# ENVIRONMENTAL REVIEW TEAM REPORT

SKY MEADOW SUBDIVISION  
BETHLEHEM, CONNECTICUT

FEBRUARY 1980

FIGURE 2.  
SIMPLIFIED SITE PLAN

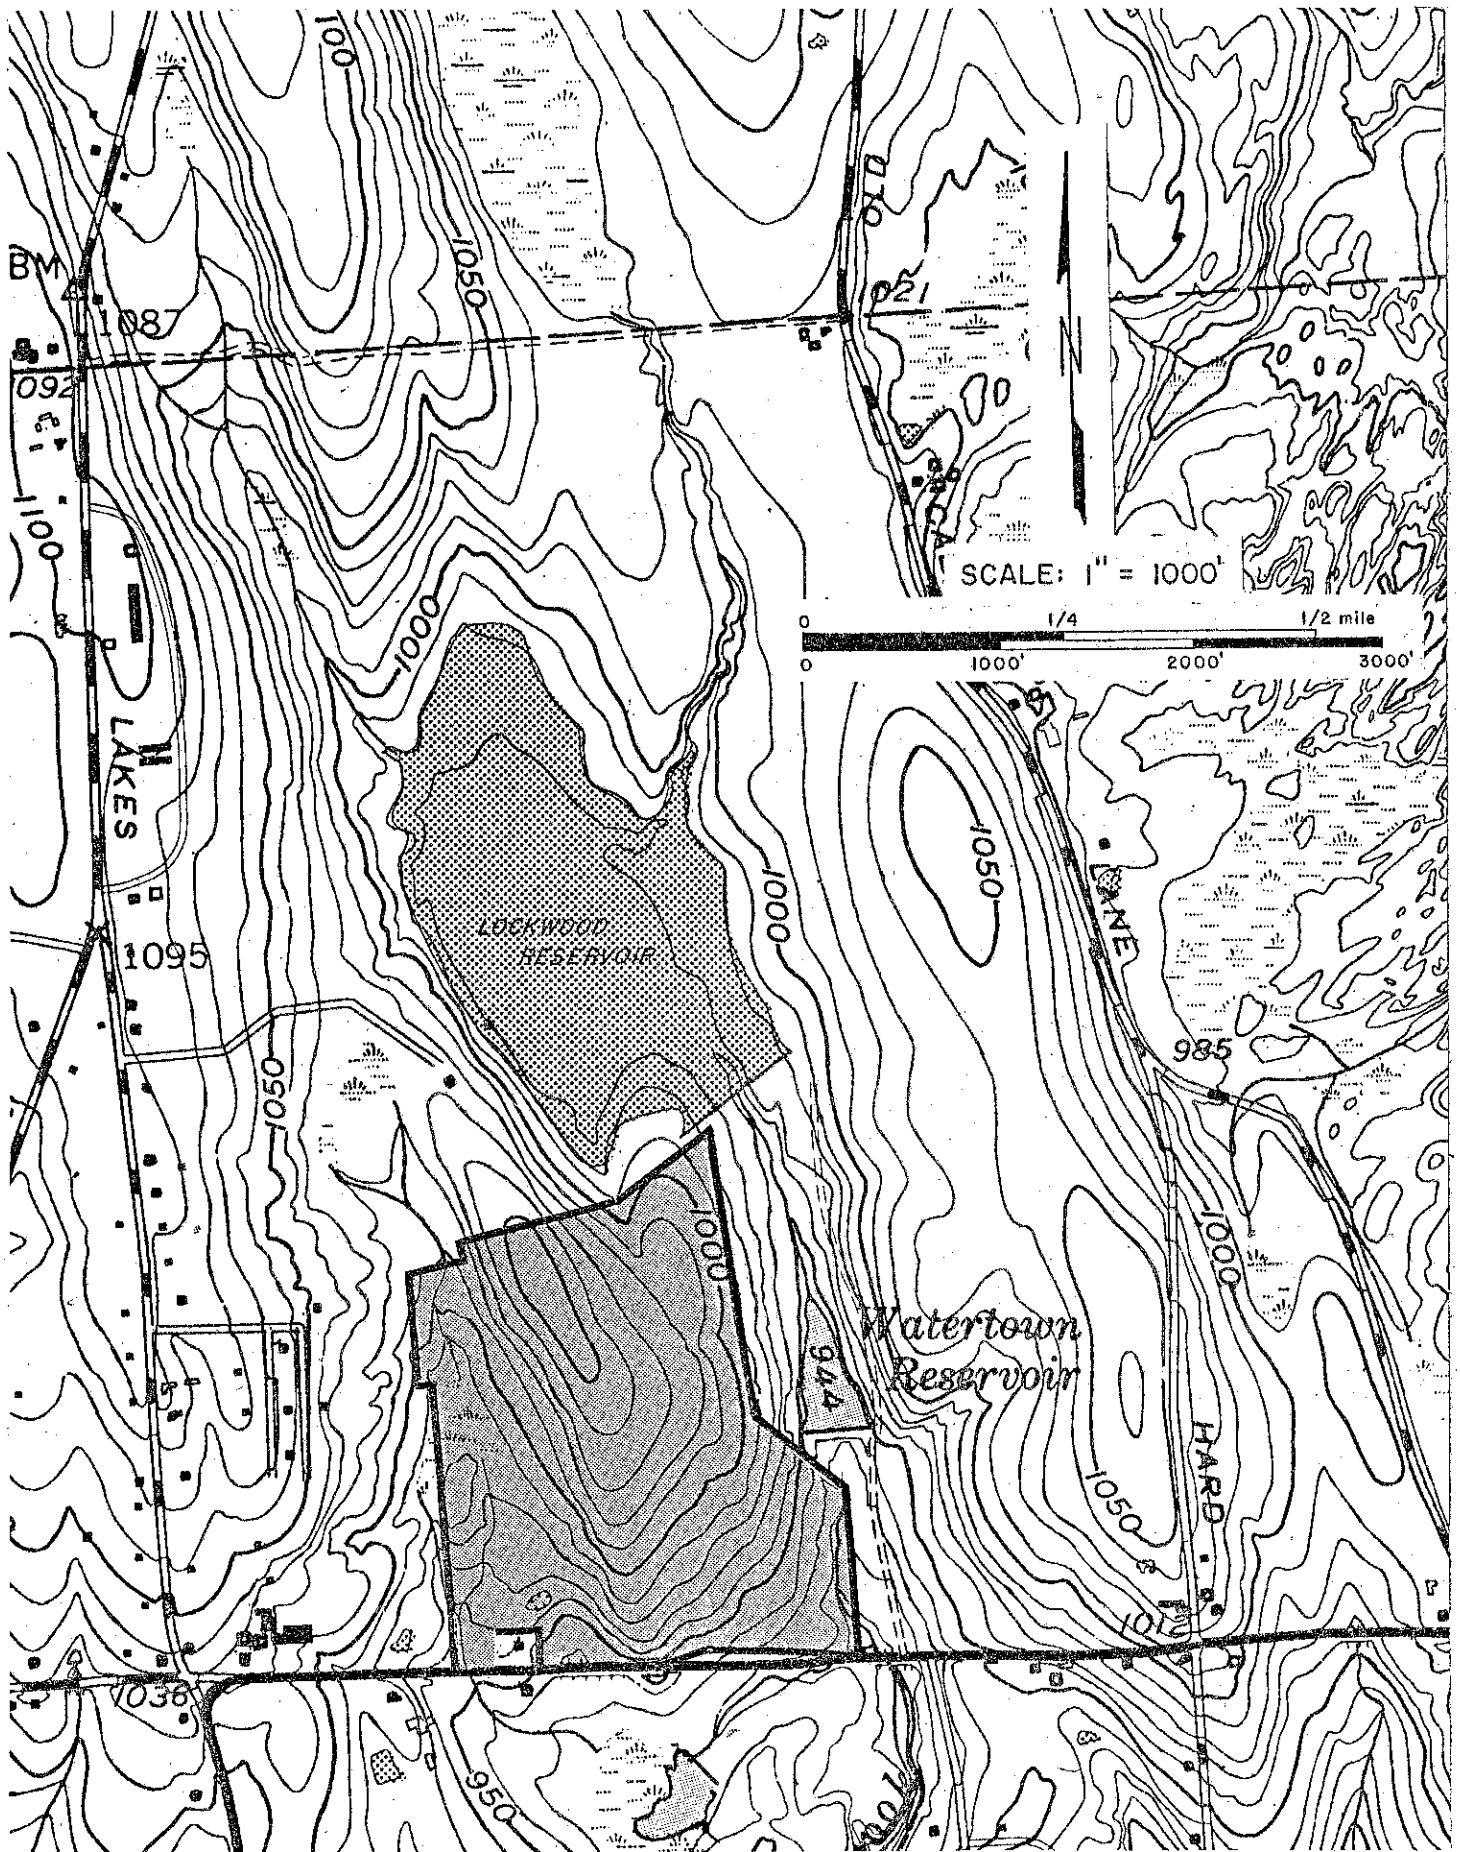
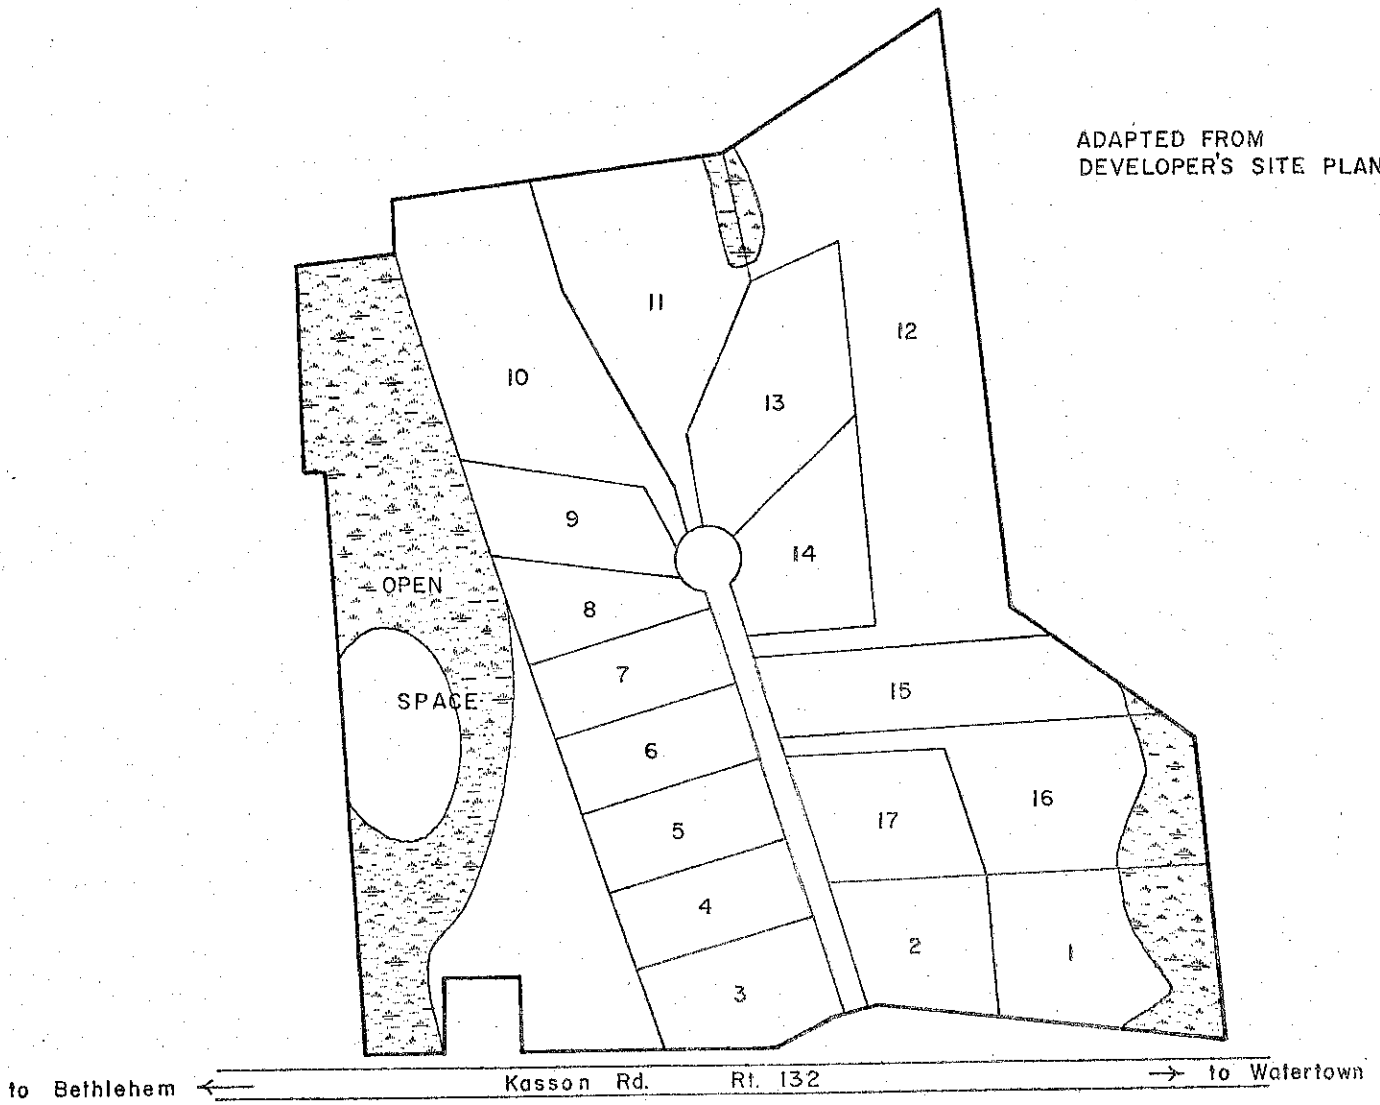
flow is relatively close to the area chosen for subsurface sewage disposal. With specific reference to Parcel #12, (small eroded watercourse to Watertown Fire District Land) and Parcels #1, 2, 17 and 16, (formation of a "Y" branch tributary which discharges to wetland area) these tributaries must be accurately located on the plan before a complete evaluation of the sewage disposal potential can be made.

5) The location of test pit and percolation test holes are now shown for lots #13, 14, although the data is included in the engineering report. The location of these tests should be noted.

6) Location of the test pits and the proposed septic location for parcel #3 is in error. The proper location should be noted on the plan.

7) Tentative well locations should be revised to reflect a location which is out of the downhill flow pattern for septic systems at higher elevations (e.g. Lot #12).

10) Some sewage disposal system locations may require relocation to more suitable areas (e.g. lots #7, 8, 9, 17). Testing would be required in these new areas.

1. Increase lot sizes for lot nos. 1, 16 and 17 and require an additional dedication of land and/or 150 foot stream setback of development (including septic systems and reserve areas) to protect against pollution of watercourses in this area.

2. Decrease lot sizes in the vicinity of lot nos. 10 through 14 in keeping with the cluster design principals while providing adequate protection of Lockwood Reservoir through increased land dedication and/or setbacks surrounding the small wetland in this area.

3. Re-align the proposed subdivision road to minimize steep grades and, to the extent possible, plan storm drainage structures that discharge to the wetland areas on the western part of the property or south of Route 132. Minimum road widths should be used to reduce impermeable surface area and limit the volume of runoff together with gravel shoulders, grassed swales, and other drainage alternatives intended to disperse stormwater runoff instead of concentrating and piping runoff. Similarly, guidelines should be established for lot grading and driveway drainage that minimize off-lot stormwater runoff. Any approved stormwater piping should be equipped at point of discharge with impact basins and settling basins to trap road pollutants and avoid channel scouring.

4. Orient lot lines with the long dimension of the lot running parallel to the direction of slope. This practice serves to optimize the separation distance between subsurface sewage disposal systems and water supply wells on adjacent lots and serves to space out the sources of hydraulic loading to the soil across the slope. This is especially important in sloping hardpan soils with seasonal high water table problems where excess hydraulic loads (septic systems, curtain drains, roof and driveway runoff) can cause severe water table conditions on down-slope lots. In light of this fact, the layout of lot nos. 12, 14, and 15 may warrant reconsideration.

# VEGETATION TYPE MAP

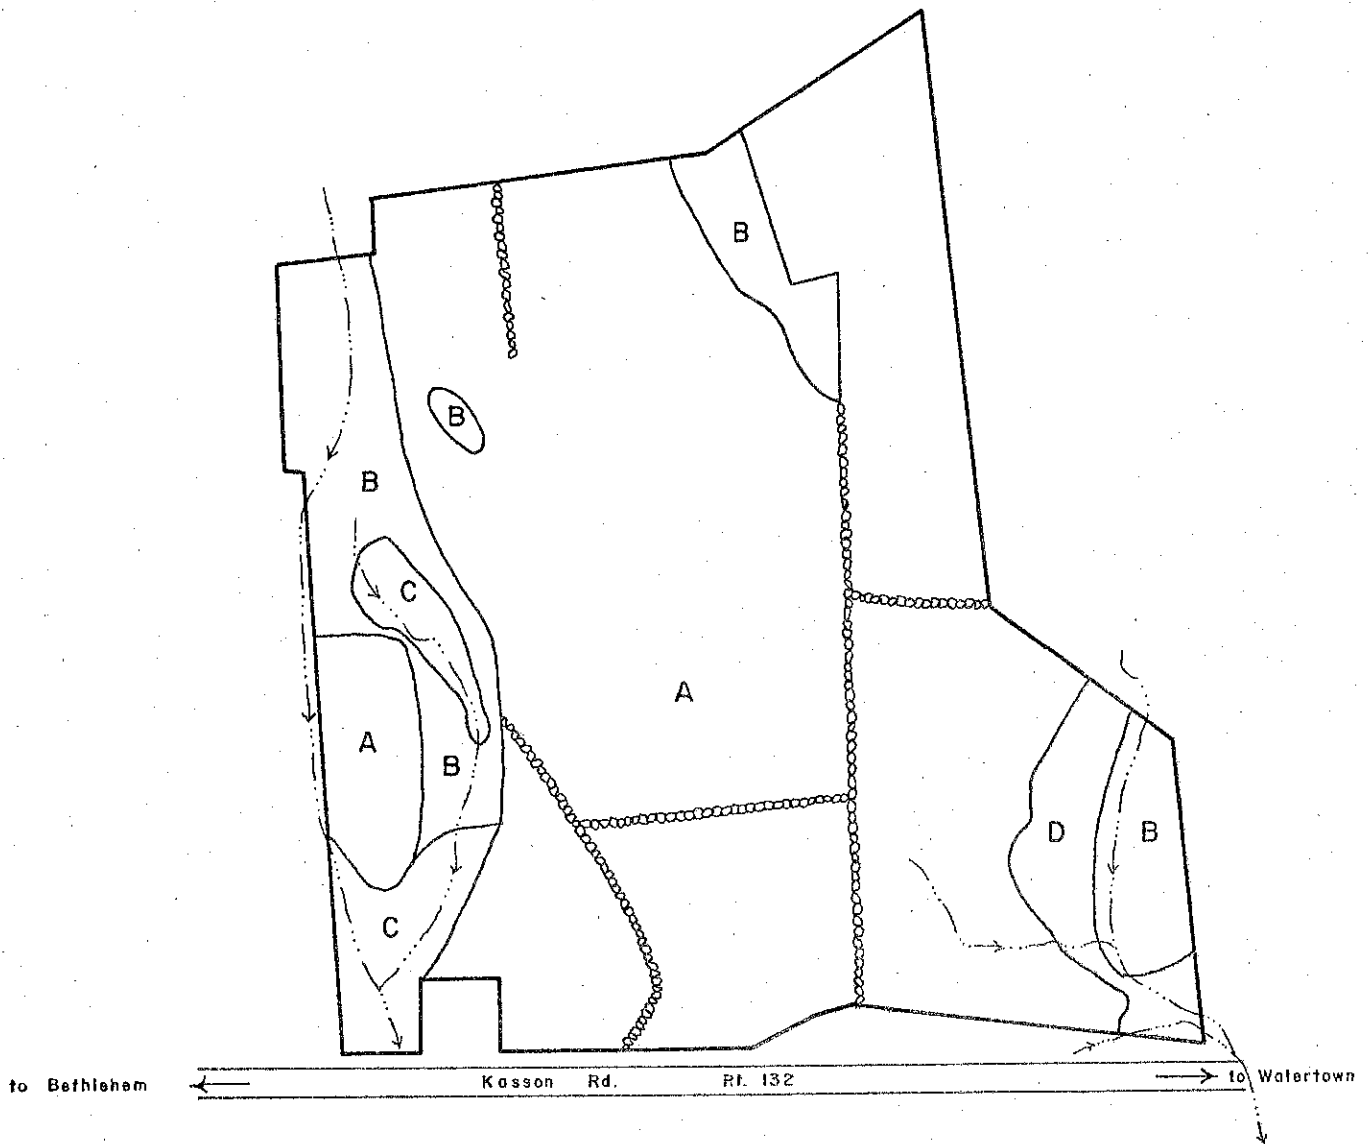
Several stone walls present on this tract have medium quality pole-size black cherry, red maple and white ash growing along them (see vegetation type map). These stone walls and the trees growing along them improve the aesthetics of the area and add to the rural character of this part of Bethlehem and therefore should be preserved if possible.

Area D has several mature white ash, shagbark hickory and sugar maple trees which, because of size, have high aesthetic appeal. These trees should also be preserved. The dead branches on these trees should be properly pruned to avoid potential hazards caused by falling branches.

Windthrow is a potential hazard in the hardwood swamp. As a result of the high water table and saturated soils, the trees present are shallow rooted and unable to become securely anchored. The crowded condition of the trees in this stand increases the potential for windthrow if land disturbances occur. At present these trees rely on each other for stability. Any openings which would allow wind to pass through rather than over this stand will increase the windthrow hazard and should be avoided if possible.

Although it is usually not feasible from an economic standpoint to practice timber management in hardwood swamp areas (such as area B), light thinnings in these areas from time to time can benefit and improve vegetation stability. Thinnings which remove about one quarter of the volume will reduce competition between residual trees, allowing them to respond by increased crown and root development, without increasing windthrow potentials. As the higher quality trees and desired species (such as white ash and sugar maple) are favored, and become healthy, the entire stand becomes more stable.

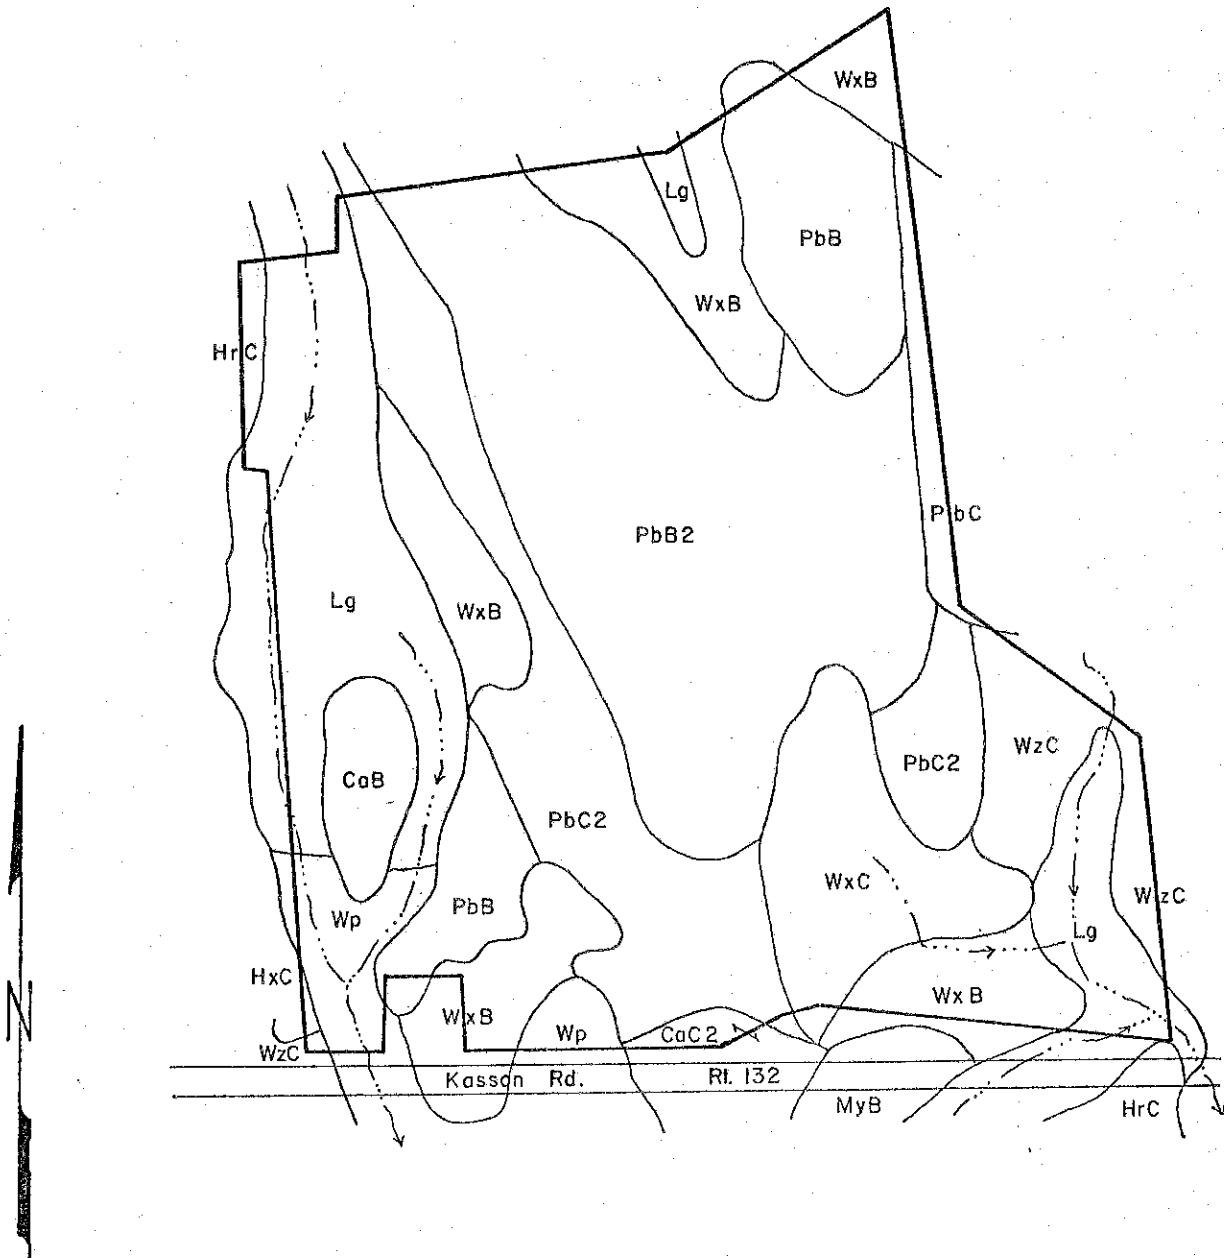
The current proposal for subdivision access onto Route 132 (Kasson Road) would create a potentially hazardous intersection due to inadequate line-of-sight distance. Vehicles leaving the subdivision, turning east onto Route 132 have an obstructed view of traffic traveling east on Route 132 due to a rise in the road. Similarly, vehicles stopped on Route 132 waiting to make a left turn into the subdivision would be hidden from view from eastbound traffic on Route 132. Line-of-sight distance east onto Route 132 is currently approximately 100 feet and the suggested minimum standard is 400 feet for vehicle speeds of 50 m.p.h.

This proposed intersection location should be relocated to provide a minimum of 400 feet line-of-sight in both directions along Route 132. This could most easily be accomplished by relocating the current intersection roughly 100 feet in a westerly direction.
